**ARCHITECTURAL REVIEW BOARD  
CITY OF FREDERICKSBURG, VIRGINIA  
AGENDA  
September 12, 2016  
7:00 P.M.  
COUNCIL CHAMBERS, CITY HALL**

**TO:** ARCHITECTURAL REVIEW BOARD  
**FROM:** Kate Schwartz, Historic Resources Planner  
**DATE:** August 8, 2016  
**SUBJECT:** Certificate of Appropriateness for demolition and new construction at 100 Hanover Street  
 1<sup>st</sup> review for demolition and site planning, scale, and massing

3 SECTION

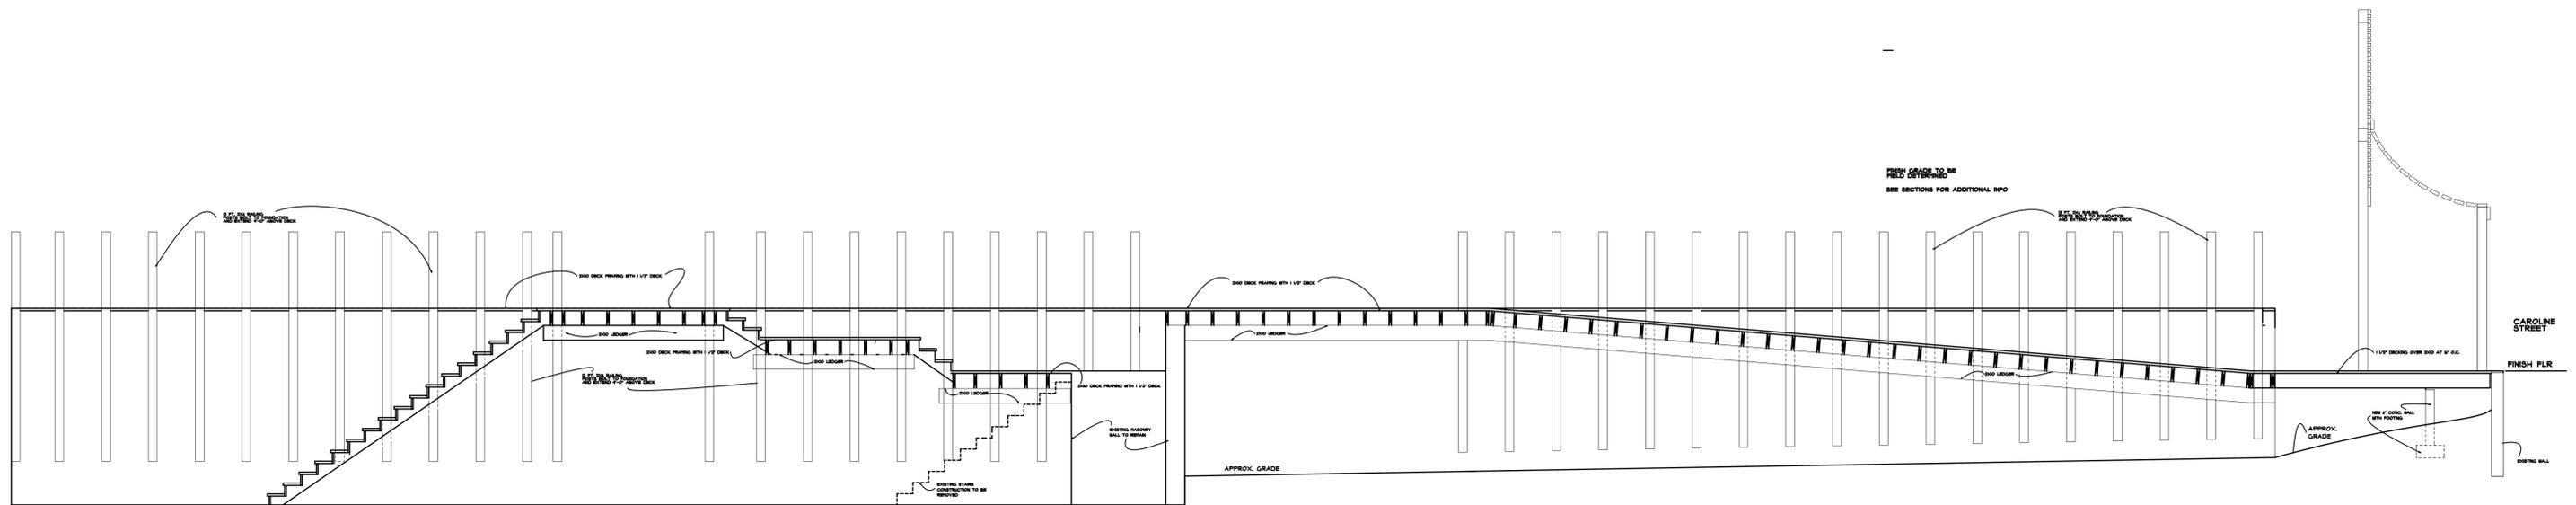
**The site planning, scale, and massing of this structure is consistent with traditional patterns throughout the Historic District and approval is recommended.** A second public hearing will be held to evaluate the materials, design details, and the project in its entirety. At that time, the applicant should be prepared to discuss:

- Materials and material finishes including the deck surface and railings
- Any signage and exterior lighting
- Consideration of screening at the rear of the deck to hide the underside of the deck
- Additional detailing of the façade. Consider incorporating a heavier/more substantial element at the top of the façade to present a more substantial appearance in balance with the neighboring buildings.
